UNITED STATES PATENT AND TRADEMARK OFFICE

APPLICATION NO.	FILING DATE	FIRST NAMED INVENTOR	ATTORNEY DOCKET NO.	CONFIRMATION NO.
10/608,467	06/25/2003	Gary K. Burma	H0003936 US	9362
128 7590 01/17/2008 HONEYWELL INTERNATIONAL INC. 101 COLUMBIA ROAD P O BOX 2245 MORRISTOWN, NJ 07962-2245			EXAMINER FORTUNA, JOSE A	
			ART UNIT 1791	PAPER NUMBER
			MAIL DATE 01/17/2008	DELIVERY MODE PAPER

Office Action Summary**Application No.**

11. The prior art made of record and not relied upon is considered pertinent to applicant's disclosure in the art of "System for Controlling the Properties of a Sheet Material."

Different fan sprays = different shape

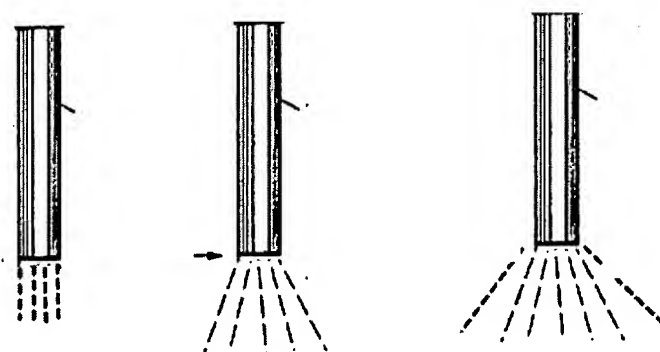
Deligt teaches a method and apparatus for leveling the cross-direction profile of stock slurry on a paper machine see abstract. Deligt discloses the use of actuators comprising nozzles distributed in the cross-machine direction of the web, stock, see abstract and he teaches that the valves are controlled to control the flow rate and spray a pond of fluid

along a common line, i.e., controlling the shape of actuator response as claimed. Figure 1 shows also the use of scanners (16) downstream of the actuators. Delight teaches that the valves are controlled using three binary control to activate different capacity spray nozzles to achieve eight distinct flow rates over the full control range and each valve can be restricted to different flow rate, i.e., the magnitude and the shape of the actuator response, by controlling the amount of fluid through the selected valve, are controlled. Note that it would be obvious to one of ordinary skill in the art to individually control the shape and magnitude of each nozzle, based on the fact of new developments in the computer art, see below. Also the references teach that if a more accurate profile is desired the nozzles can be operated individually. Specifically Delight teaches that the each nozzle can be controlled to vary the magnitude and then the nozzles are adjusted to change the fan spray, see paragraph bridging columns 4 and 5. The fan spray changes reads in the change of shape, since changing the width of the spray changes the shape, see figure below.
